December 7, 2021

**NRHS ANNEX ROOF REPLACEMENT
For
North Rockland Central School District
MSA File No. 41056**

Re: ADDENDUM NO. 1

Roof Details	A-500
--------------	-------

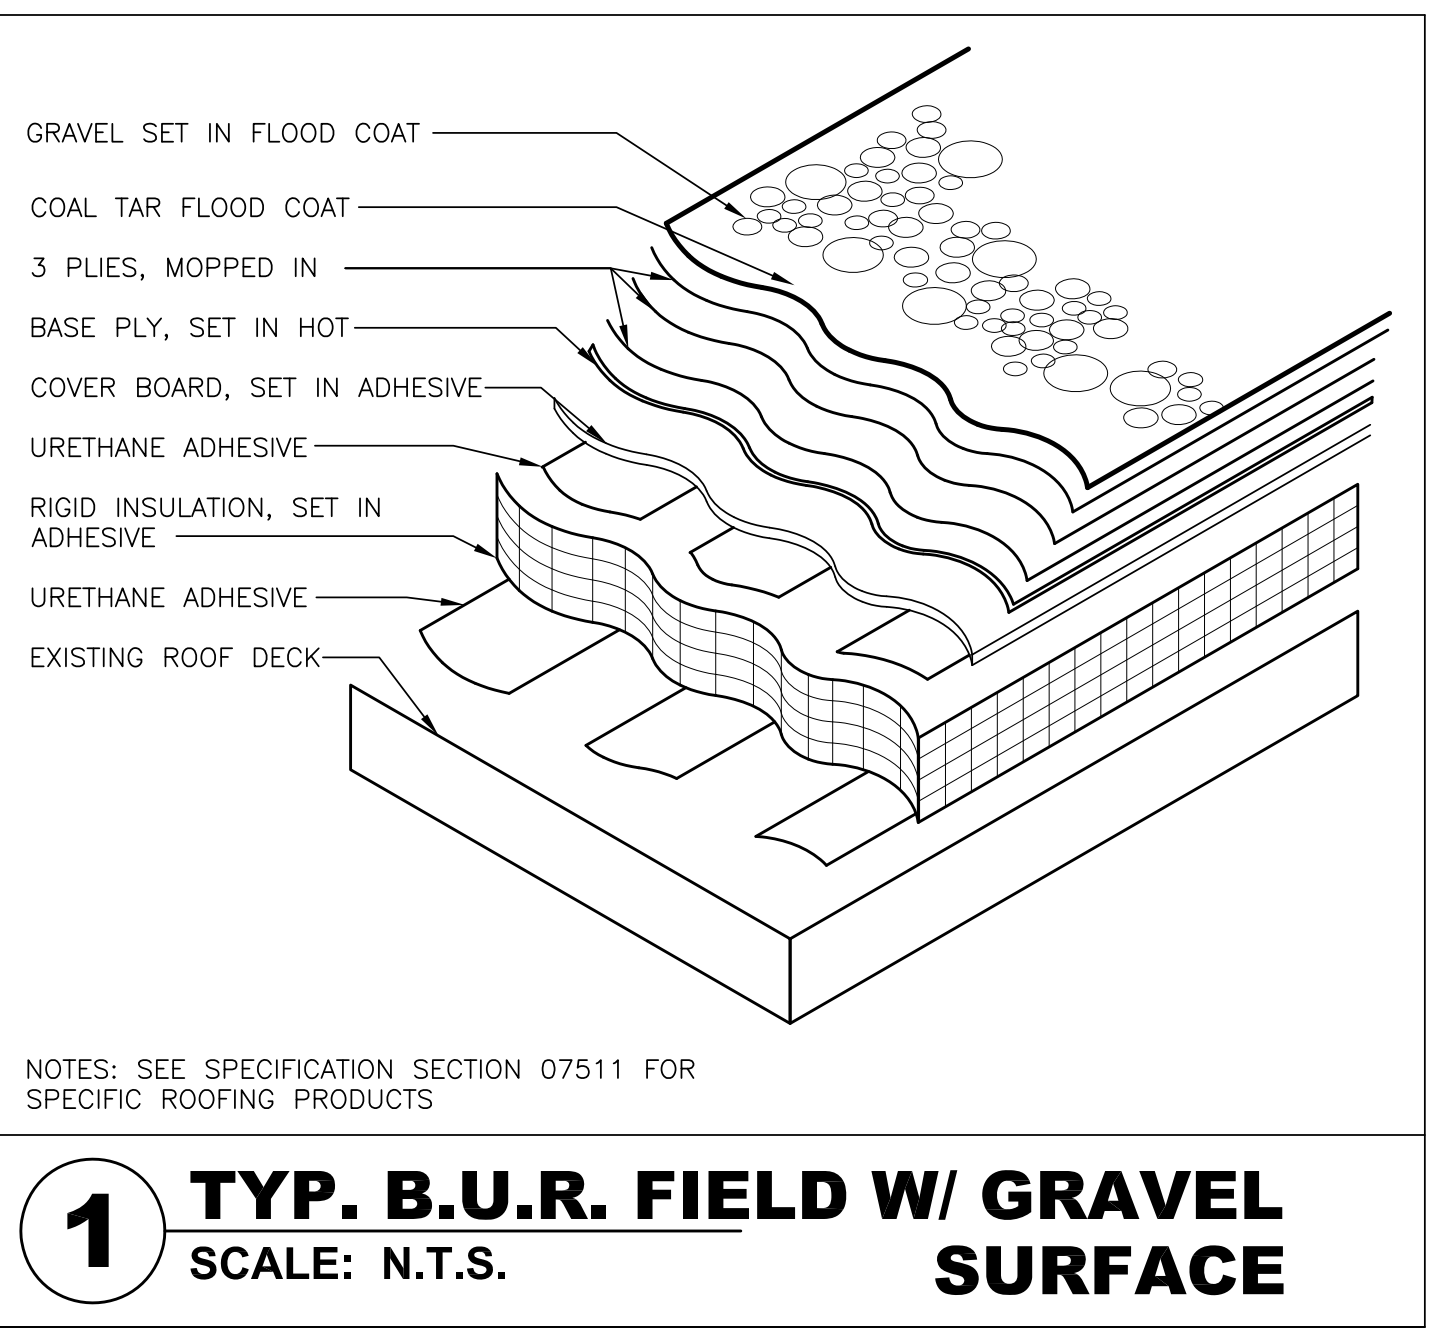
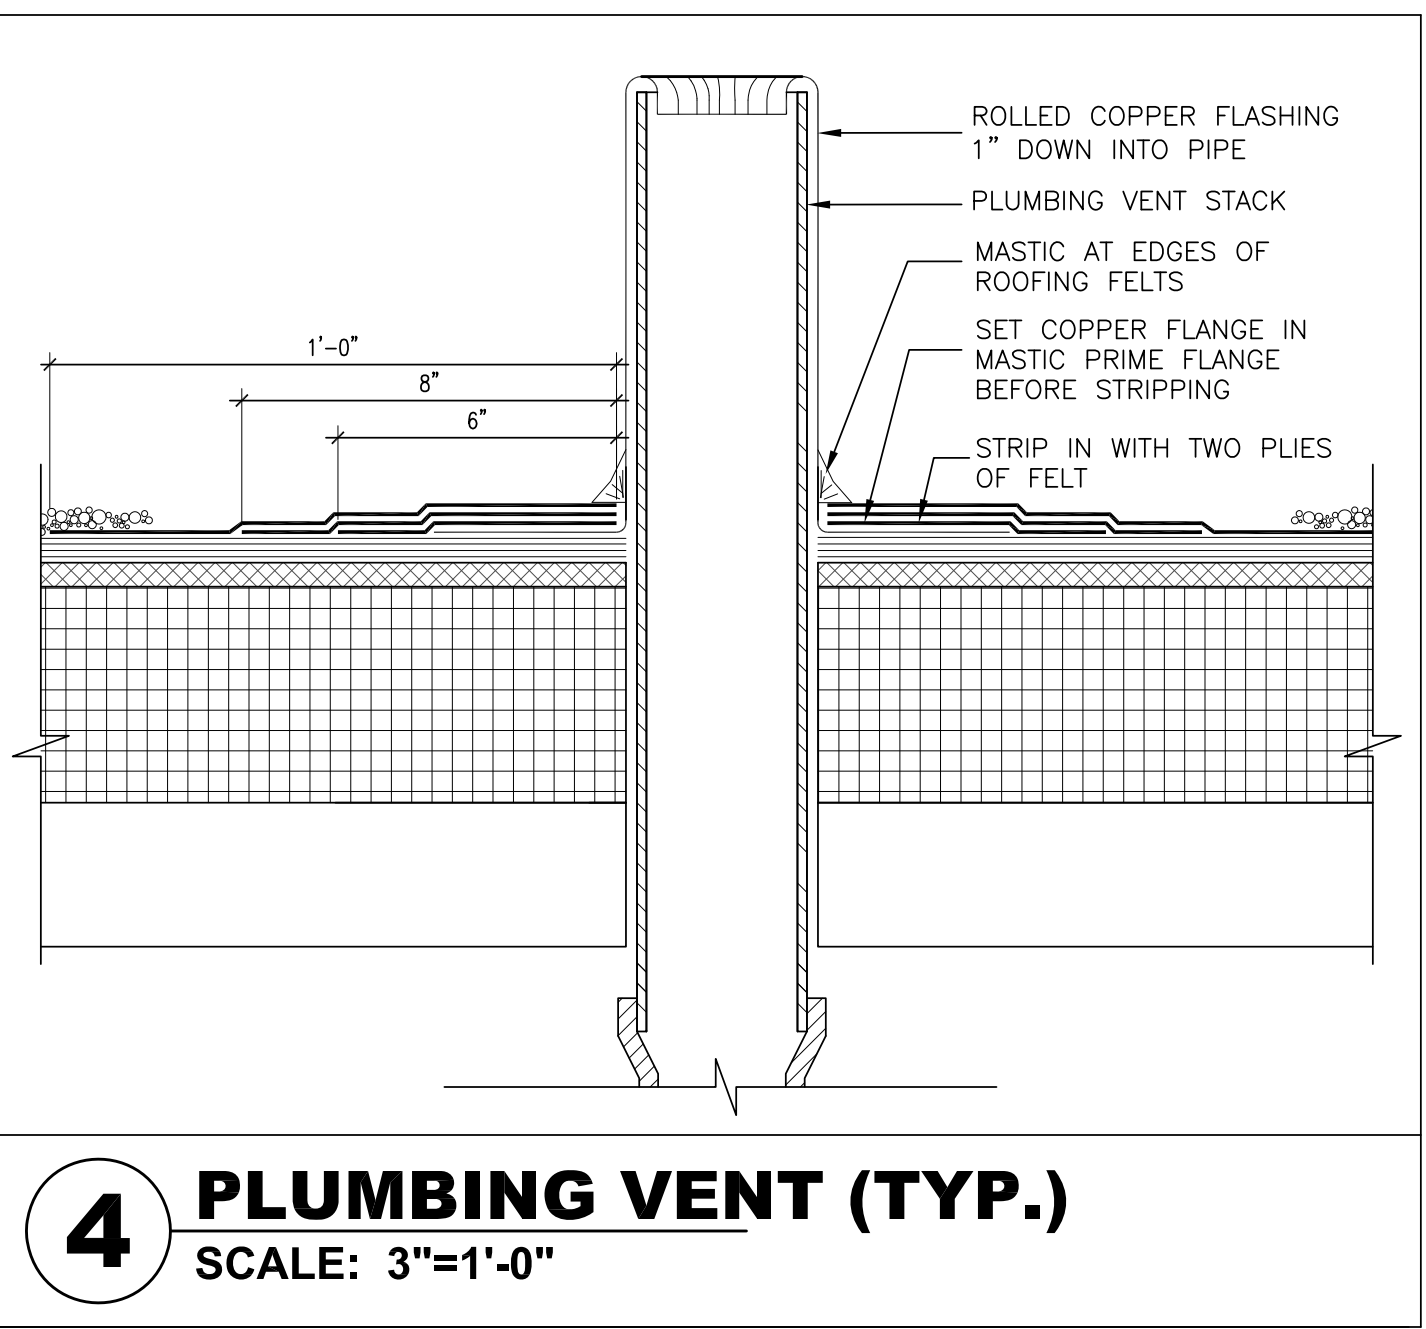
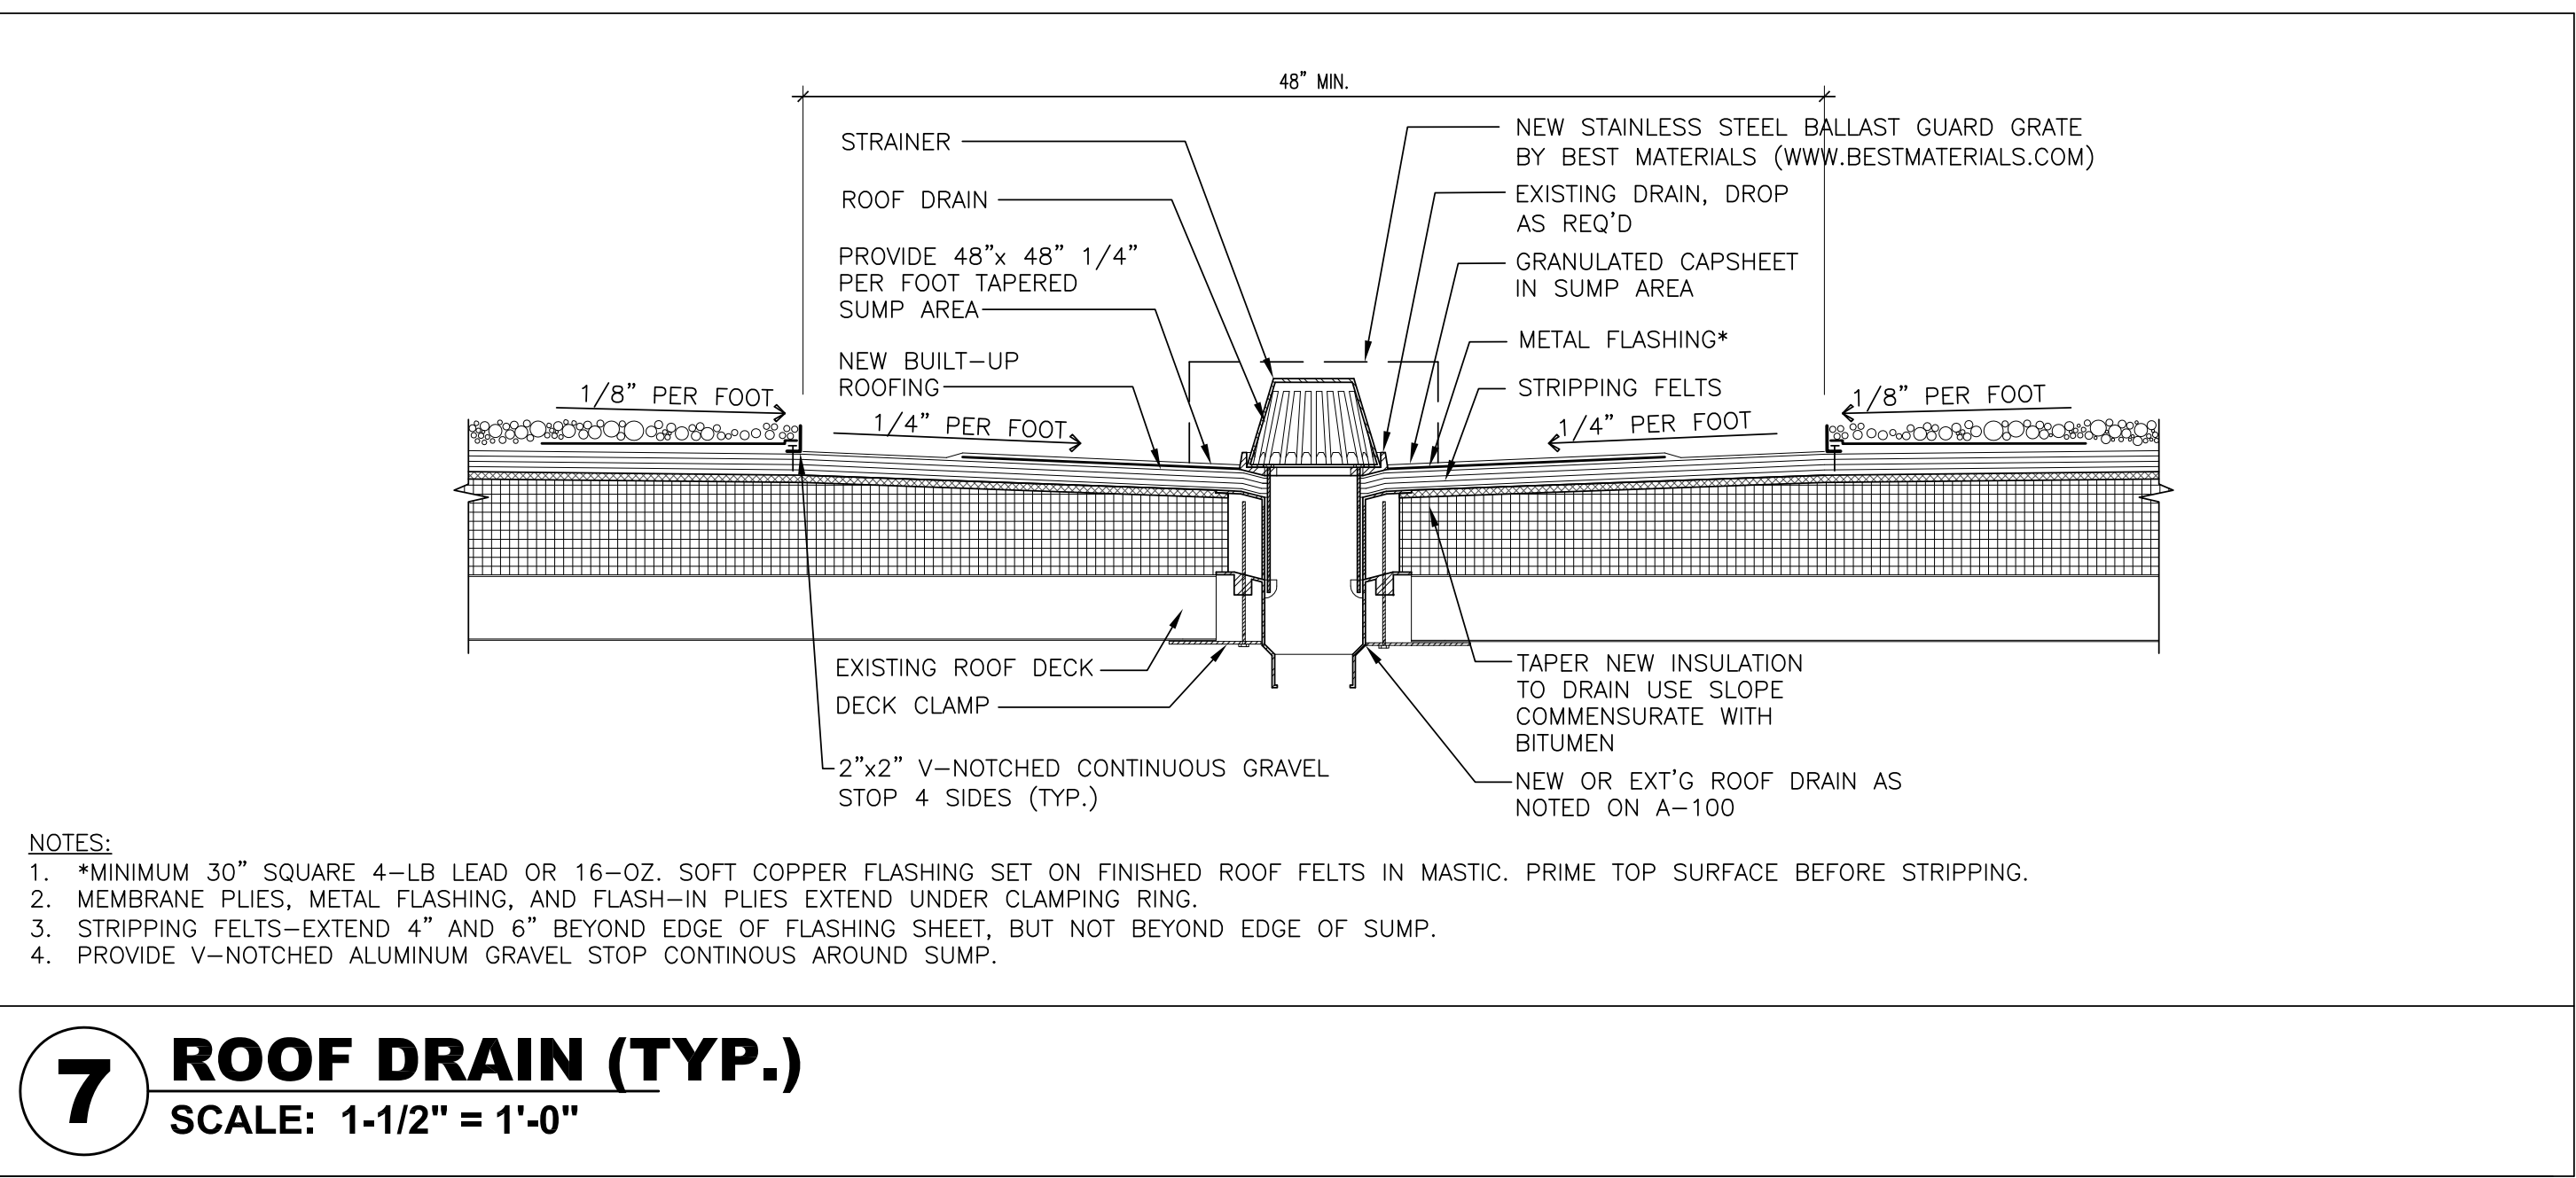
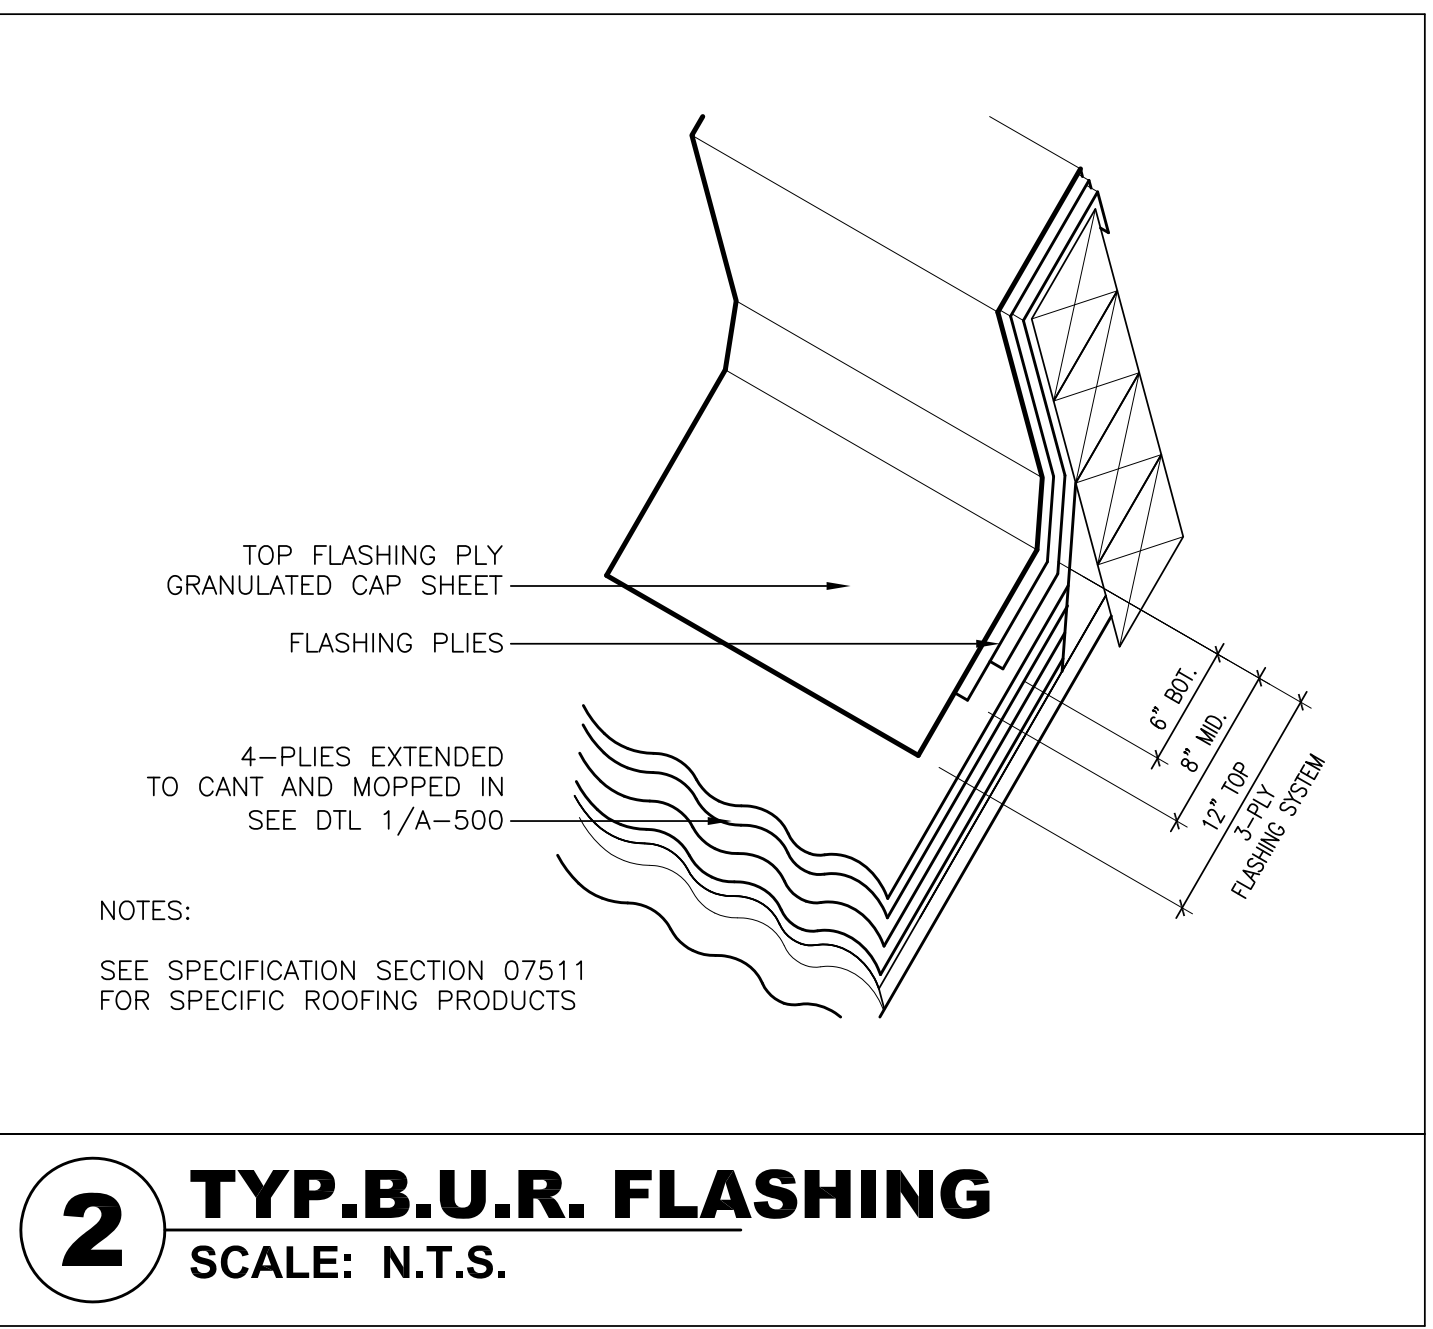
- 6) Additional pipe raising detail is provided. Detail 10/A-500 has been added and coordinated with drawing A-100. Use attached revised drawing A-500 Roof Details.
